SCHWEIZER SERVICE BULLETIN

DB-029
13 Feb 2009

SUBJECT: LONGITUDINAL TRIM ASSEMBLY SPRING ATTACHMENT

MODELS AFFECTED: All 269D Series Helicopters Serial Numbers 0001 through 0077A.

Figure DB-029-1. Longitudinal Trim Assembly Spring Attachment

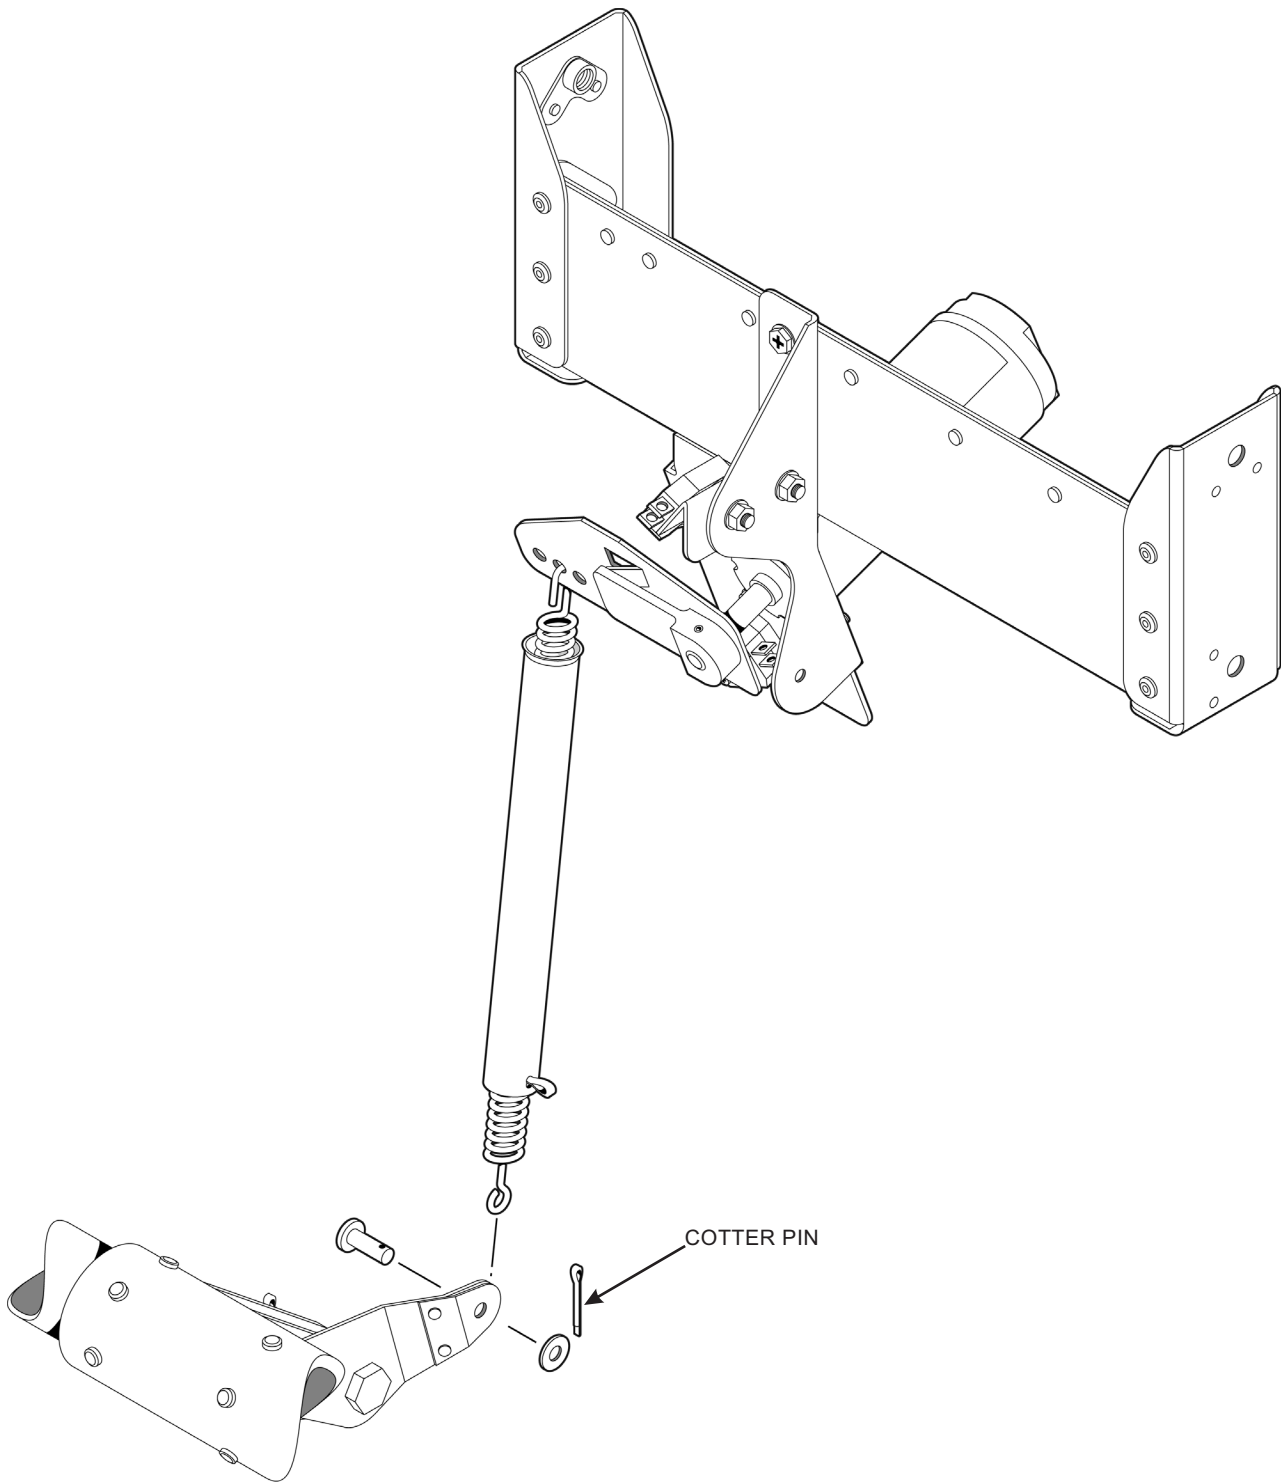
PREFACE: • The longitudinal trim spring assembly is attached to a bracket on the longitudinal cyclic control torque tube by an MS20392-2C7 clevis pin. The clevis pin is secured in place by an MS24665-20 cotter pin. Schweizer Aircraft Corp. has discovered that the dimension tolerance of the cotter pin can allow the head of the pin to slip through the clevis pin hole. This Service Bulletin replaces the MS24665-20 cotter pin with an MS24665-1011 cotter pin.

Failure to comply with this bulletin may lead to longitudinal cyclic forces that cannot be trimmed to a neutral feel when the cyclic is moved longitudinally towards the aft position, thereby increasing pilot workload.

- a. Gain access to longitudinal trim assembly in accordance with instruction in Basic HMI, Section 8 or Config. "M" Basic HMI, Section 9.
- b. Locate clevis pin shown in Figure DB-029-1 and replace existing cotter pin that is installed in clevis pin with an MS24665-1011 cotter pin. Installation of the cotter pin should be in accordance with AC 43.13-1B Section 7, Paragraph 7-127.
- c. Reinstall all interior panels and components removed to gain access to trim assembly.
- d. Record compliance with this Service Bulletin in the aircraft records.
